## DEVELOPMENT REVIEW BOARD REPORT

Case Number/ Project Name	82-DR-1984#2 Scottsdale Bible Church Ren	novation	
LOCATION	7601 E. Shea Boulevard		
Request	Request approval of a site platexisting structures, including construction of three (3) new	removal of one existing	
OWNER	Scottsdale Bible Church 480-824-7248	Engineer	Erie & Associates 602-954-6399
ARCHITECT/ DESIGNER	Barduson Architecture 480-967-7007	APPLICANT/ COORDINATOR	Steve Barduson Barduson Architecture 480-967-7007
BACKGROUND	Zoning.  The site is zoned R1-35 (Single Family Residential). The R1-35 zoning district allows for 35, 000 square-foot or larger residential lots. Churches and places of worship are allowed uses within this zoning district with the approval of the Development Review Board.  Context.  The developed site is located on the southeast corner of Shea Boulevard and Miller Road.  Adjacent Uses:

# Stipulations for Case: Scottsdale Bible Church Renovation Case 82-DR-1984#2

A2.1C

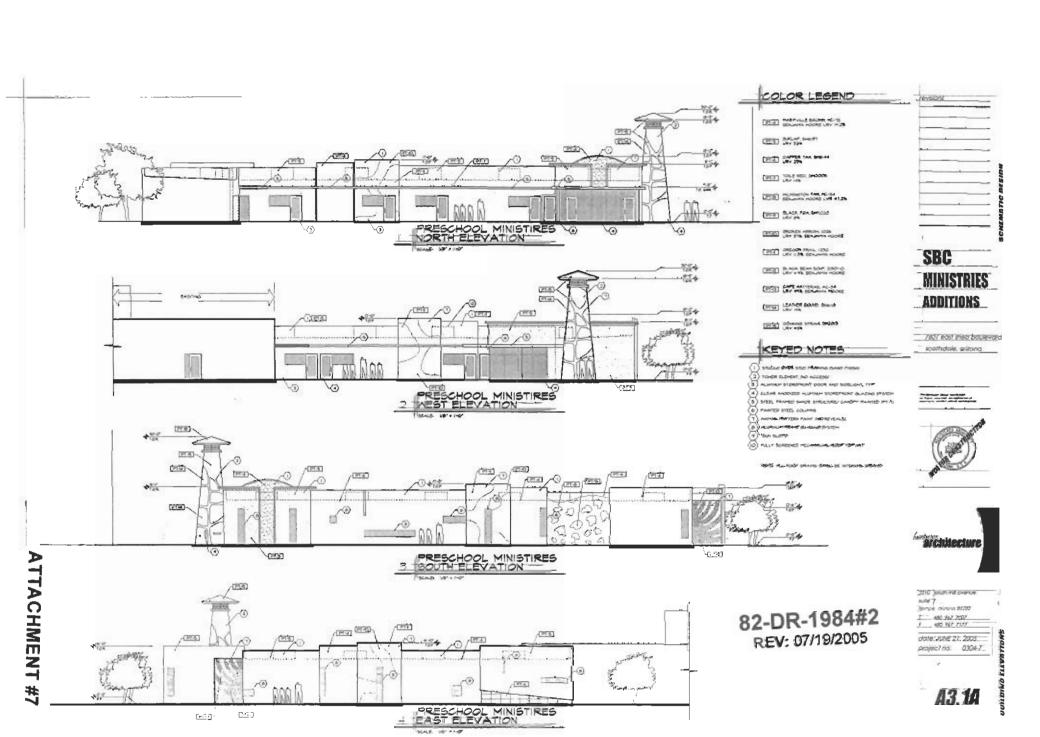
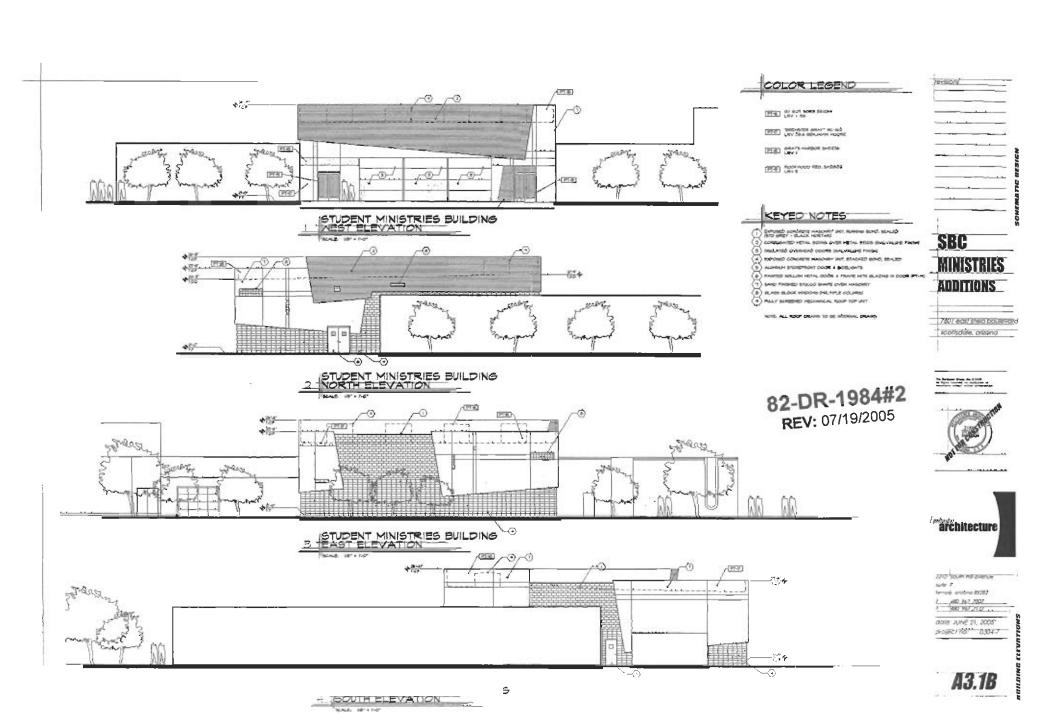
- 7. "Animal patterns" on exterior elevations shall be restricted to the new Preschool Ministries Building only.
